GOVERNMENT OF THE DISTRICT OF COLUMBIA
DEPARTMENT OF GENERAL SERVICES

SOLICITATION DCAM-22-CS-RFP-0011

**REDEVELOPMENT ST. ELIZABETHS EAST CAMPUS-
MICROGRID PROJECT**

AMENDMENT NO. 5

LOT 1 - UCC SURVEY

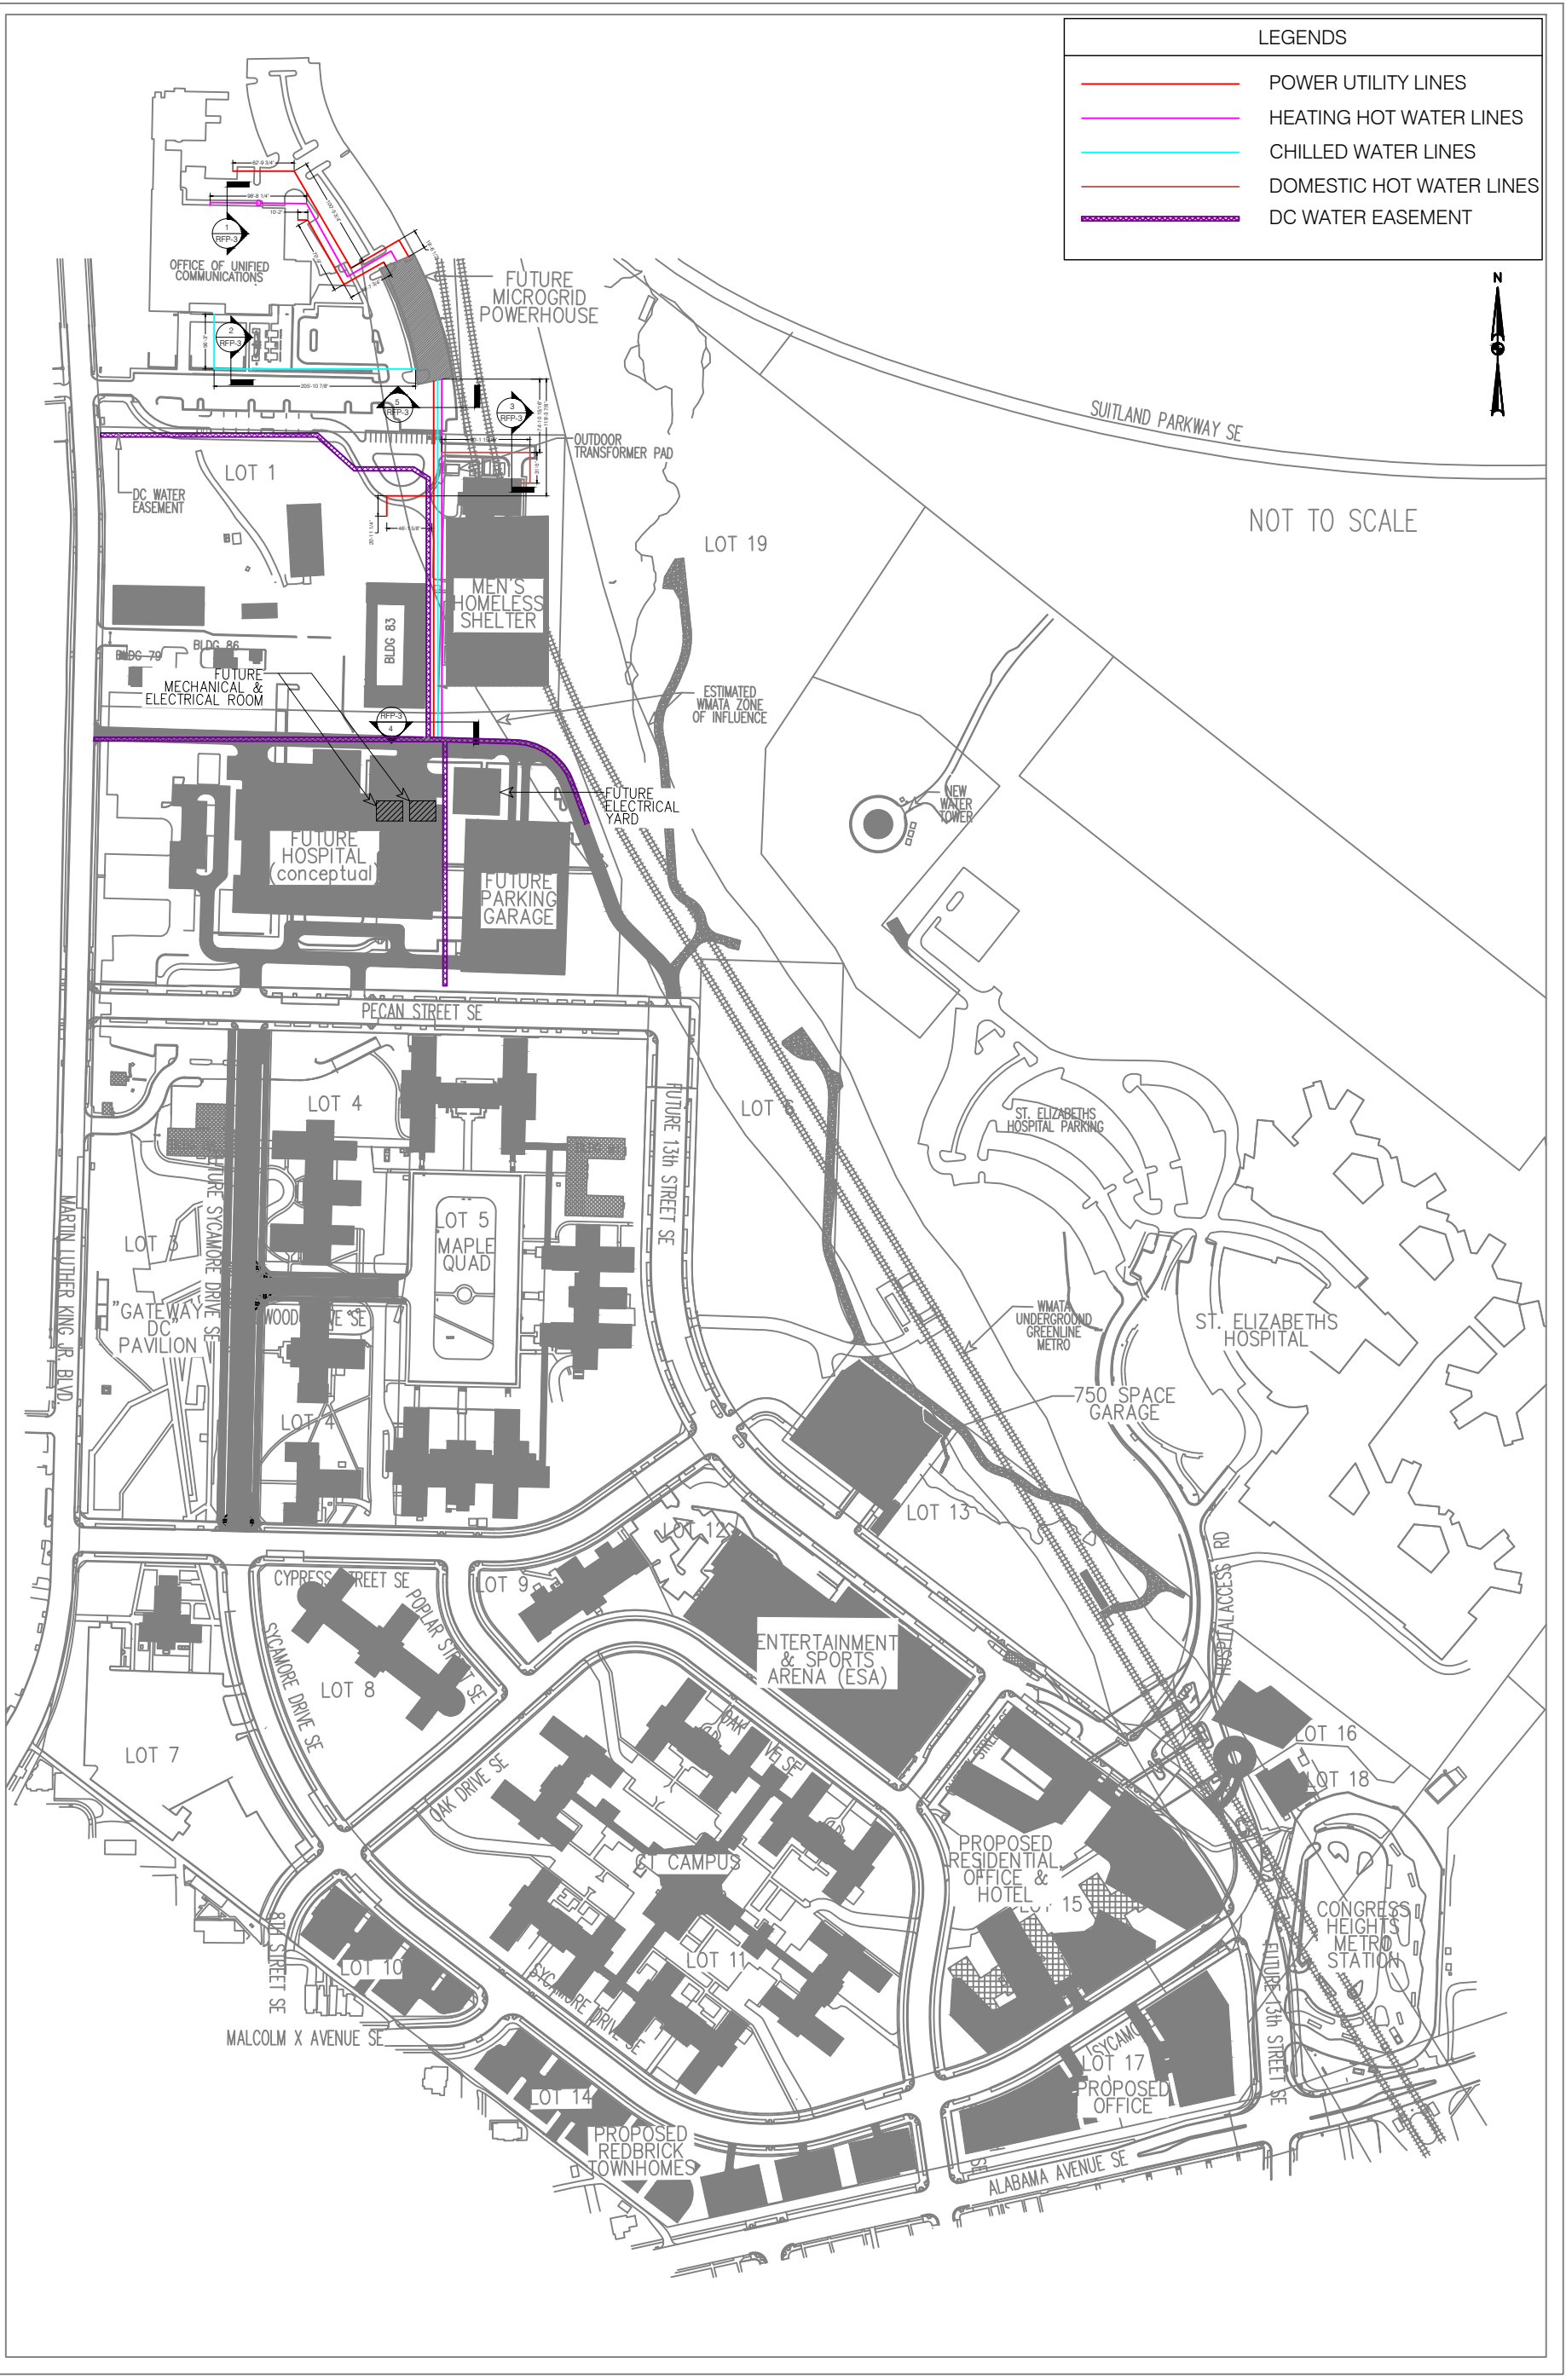
1. Section 1.15 Attachment A7 Site Information

Delete: In its entirety

Insert: Site Information (revised) provided as Exhibit 1 to Amendment 5

The candidate site for the Microgrid Powerhouse is shown on the survey drawings below, including basic dimensions.

The approved pathway for Pepco ductbanks serving the Hospital is shown on the drawings below, subject to changes by the Hospital or Pepco prior to actual construction.

The District Department of Transportation is currently engaged in a planning process for adding a new walking / bike path through the valley, as shown in the drawings below.
